**** MANDATORY ****

Service Letter No: SL-200C/400C-013015

SUBJECT: Actuating pin base to outer ferrule attachment bolt hole depth.

MODELS AFFECTED: Model 200C; all propellers with blade serial numbers 200C-385 and lower
Model 400C; all propellers with blade serial numbers 400C-226 and lower

Figure 1

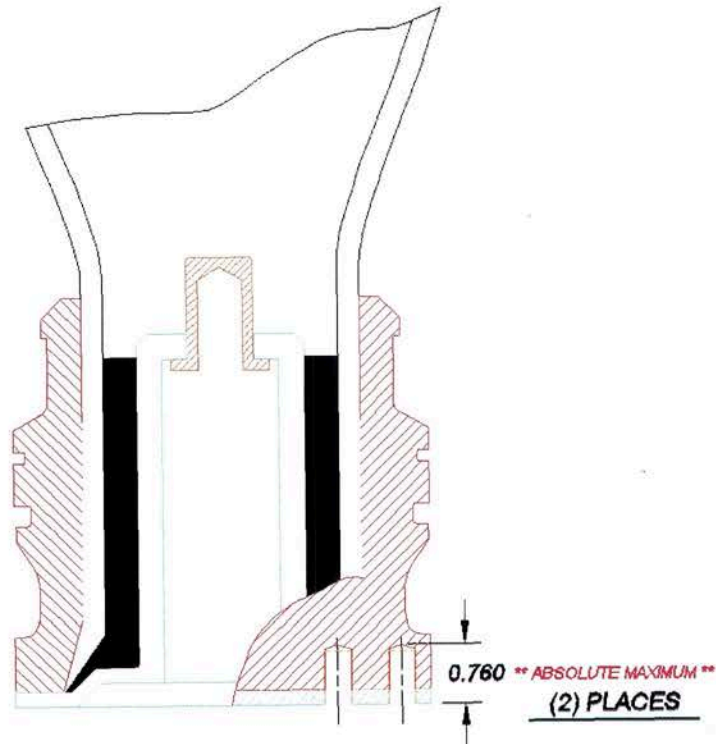
REASON: The actuating pin base mounting holes could vary in depth. In some cases inconsistent hole depths could compromise the integrity of the blade outer ferrule which can lead to premature material fatigue and possible failure of the ferrule, which can in turn lead to the loss of blade retention.

Through testing and / or removal of the 5/16-24 actuating pin base mounting screws the drill depth of the screw holes must be found **not to exceed 0.760"** deep from the surface of the inner ferrule to the drill point (see figure 1 below). Blades with holes exceeding this maximum allowable depth must be taken out of service immediately.

Blade ferrules that have actuating pin base holes with maximum depths of 0.760" and less and are NDT tested and verified to be structurally sound (no evidence of cracks) may be returned to service, continuing to follow the propeller 250 hour or annual tear down inspection service interval, whichever comes first.
